**AGENDA  
LANDMARK COMMISSION  
REGULAR MEETING  
4:00 p.m. Monday, May 4, 2020  
City Council Chambers, 2<sup>nd</sup> Floor of City Hall  
823 Rosenberg, Galveston, Texas**

# 20LC-037

# STAFF REPORT

1801 Avenue L

1801  
AVE-L

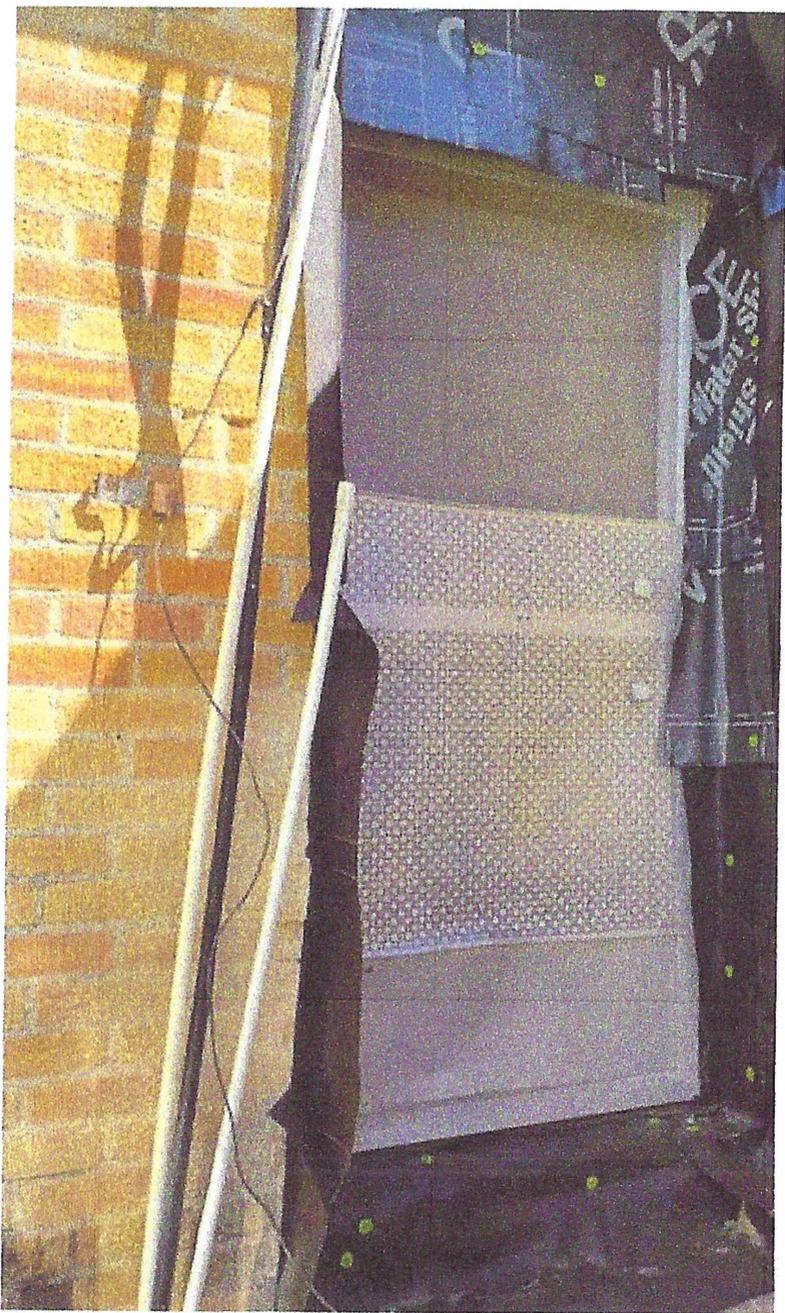
- 1) The applicant shall conform to the design, material, and placement shown in Attachment A of the staff report with the following modifications:
  - a. The unpainted masonry shall not be painted;
  - b. The existing painted wall sign shall remain exposed; and
  - c. Door 1 shall remain in its current configuration.
